Access Compliance Report Public Rights-of-Way (Curb Ramps)

Intersection ID: 49140	Main Street: POPE_FARM_RD	Cross Street: CEMKEY_WAY_CT	Location: SW
ADA ID: 7544424D5F0D	Ramp Type: Perp	Initial Pass/Fail: Fail	Overall Compliance: No Severity Score: 21.25

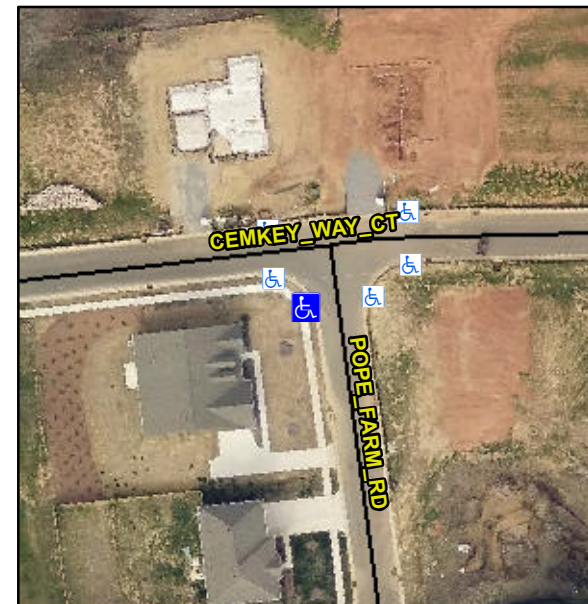
Not Found, R304.5.1, R304.5.3

Compliance	Description	Data	Compliance	Description	Data
N/A	Ramp Length (in)	45.5	Yes	Ramp Slope (%)	6.4
No	Ramp Width (in)	43.0	No	Ramp XSlope (%)	5.2
N/A	Flare Type LT	N/A	N/A	Flare Type RT	N/A
N/A	Flare Slope LT (%)	N/A	N/A	Flare Slope RT (%)	N/A
N/A	Flare Traversable LT?	N/A	N/A	Flare Traversable RT?	N/A
N/A	Landing Length (in)	N/A	N/A	DWS Provided?	N/A
N/A	Landing Width (in)	N/A	N/A	DWS Contrast?	N/A
N/A	Landing Slope (%)	N/A	N/A	DWS Length (in)	N/A
N/A	Landing X Slope (%)	N/A	N/A	DWS Full Width?	N/A
N/A	Landing Curb? (Y/N)	N/A	N/A	DWS Offset (in)	N/A
N/A	Shared Landing?	N/A			
N/A	Gutter Ponding?	N/A	N/A	Gutter Slope (%)	N/A
N/A	Gutter Lip Ht (in)	N/A	N/A	Gutter X Slope (%)	N/A
N/A	Painted X Walk1?	No	N/A	Painted X Walk2?	N/A
	X Walk 1 Direction	To E		X Walk 2 Direction	N/A
N/A	X Walk 1 Width (in)	N/A	N/A	X Walk 2 Width (in)	N/A
	X Walk 1 Slope (%)	3.3		X Walk 2 Slope (%)	N/A
	X Walk 1 X Slope (%)	5.8		X Walk 2 X Slope (%)	N/A

Remove & Replace Entire Ramp.
